August 30, 1985
Bridgeport, CT

This is in reference to your letter dated 7/26/85 regarding our application for a byproduct materials license. Please refer to Mail Control No. 03946. The following information and modifications are supplied, as requested:

CALIBRATION OF DOSE CALIBRATOR

Item 11

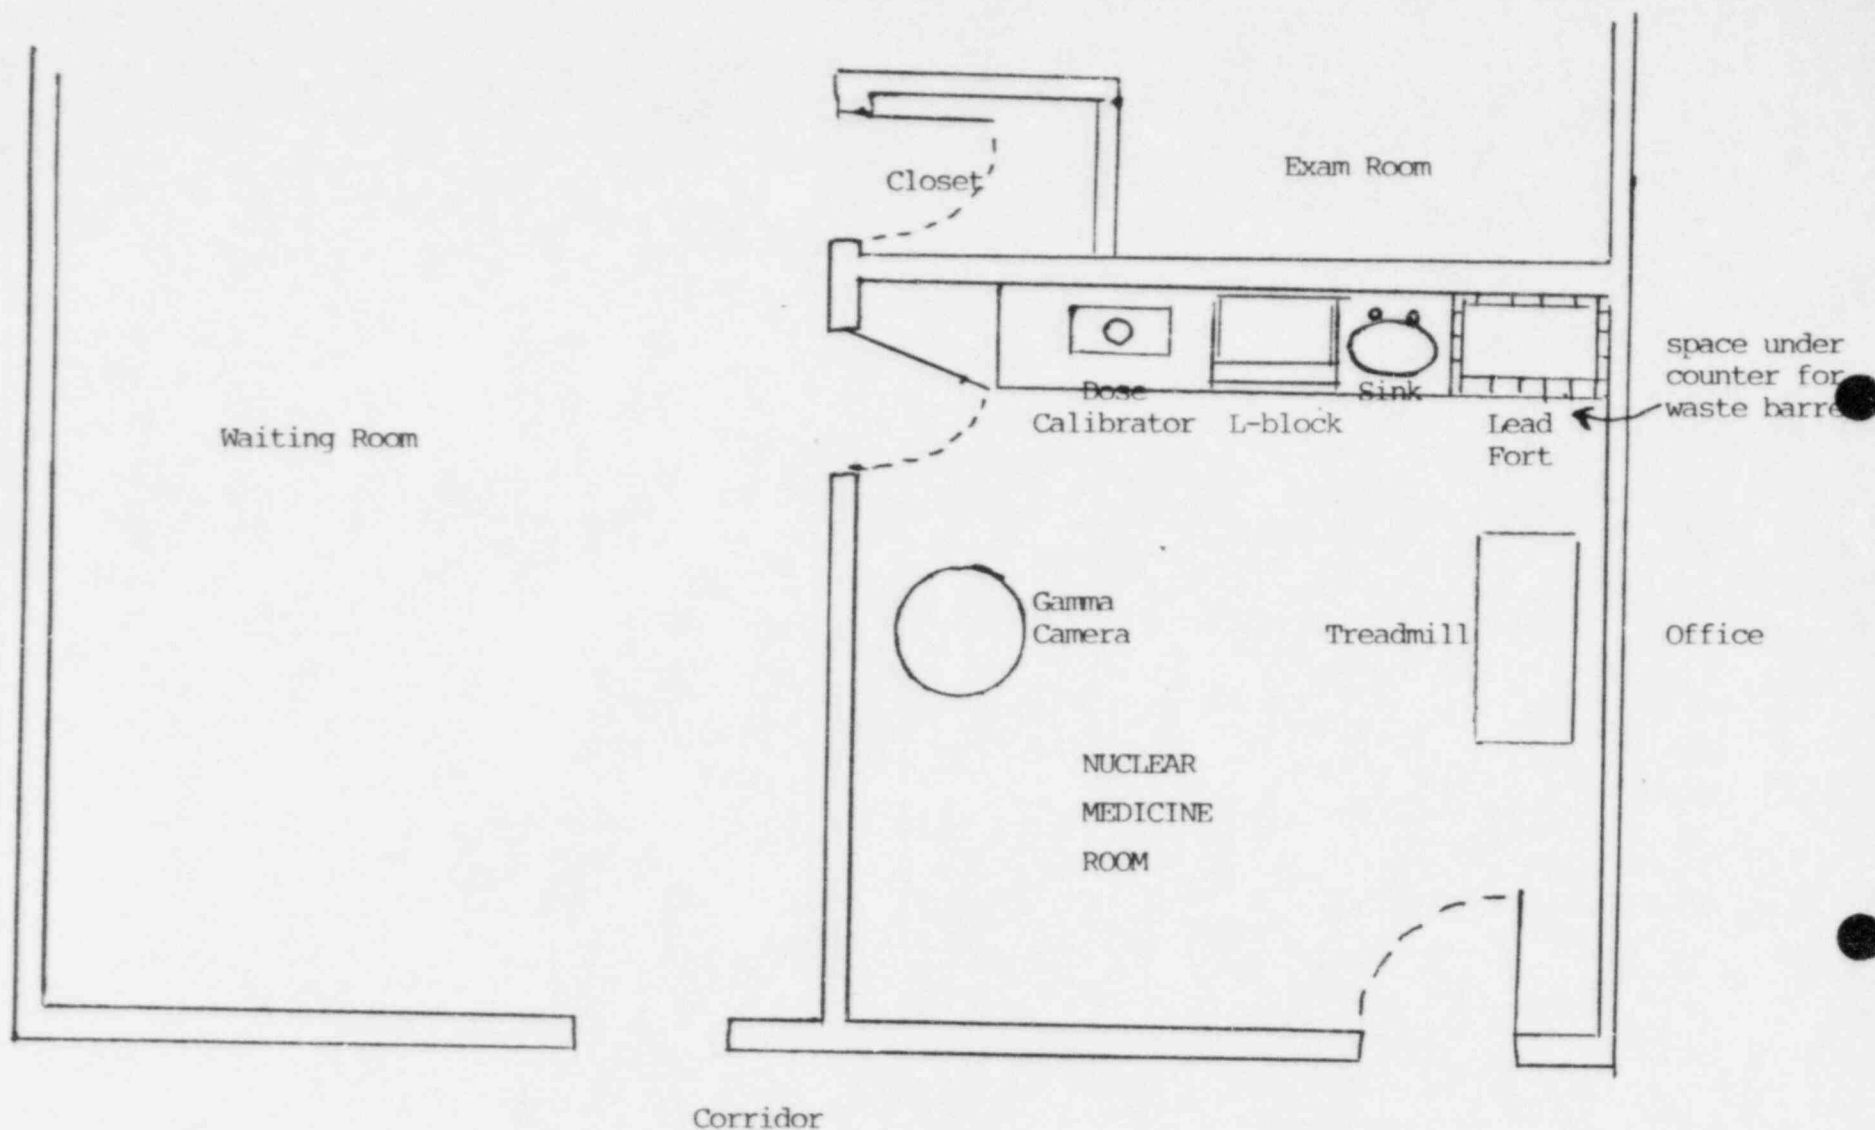
- 1) Item 10 of the application has been modified to include a Ba-133 accuracy and constancy test source. An amended copy of item 10 of the application, "Calibration of Dose Calibrator", is attached.
- 2) The shielding that we will use will include a commercial nuclear medicine L-block (with a leaded window above a $\frac{1}{2}$ " thick lead wall) on the counter top for the preparation and dispensation of Group III kit radiopharmaceuticals. Amended copies of item 11 to our application are attached.
- 3) Our "Instructions for Opening Packages Containing Radioactive Material" has been modified to include notification of the NRC Region I Office if removable contamination exceeds $0.01 \mu\text{Ci}/100\text{cm}^2$, or if external radiation levels exceed 200mR/hr at the package surface or 10mR/hr at 3 feet.

The nuclear medicine room shown on the accompanying sheet will be used for the receipt, storage (including waste), and preparation of radioactive material, as well as for patient imaging.

Radiopharmaceuticals, generators (when needed) and calibration sources will be stored in the lead fort, with sufficient shielding (mainly 2-inch thick lead bricks) to limit radiation levels in all accessible areas to less than 2mR/hr.

An L-block with a lead-acrylic or lead-glass window will be used for preparation and dispensation of radiopharmaceuticals. The counter top area will be covered with disposable pads during preparations, and both auxiliary shielding (lead bricks) and protection utensils (forceps, tweezers) will be available. Radioactive waste being held for decay will be stored in containers beneath the counter top, and shielded with sufficient lead or other material to maintain radiation levels in all accessible locations at less than 2mR/hr. The room shall be so shielded that radiation levels in surrounding unrestricted areas are less than 0.2mR/hr.

Lead fort construction:
lead bricks, 2" thick
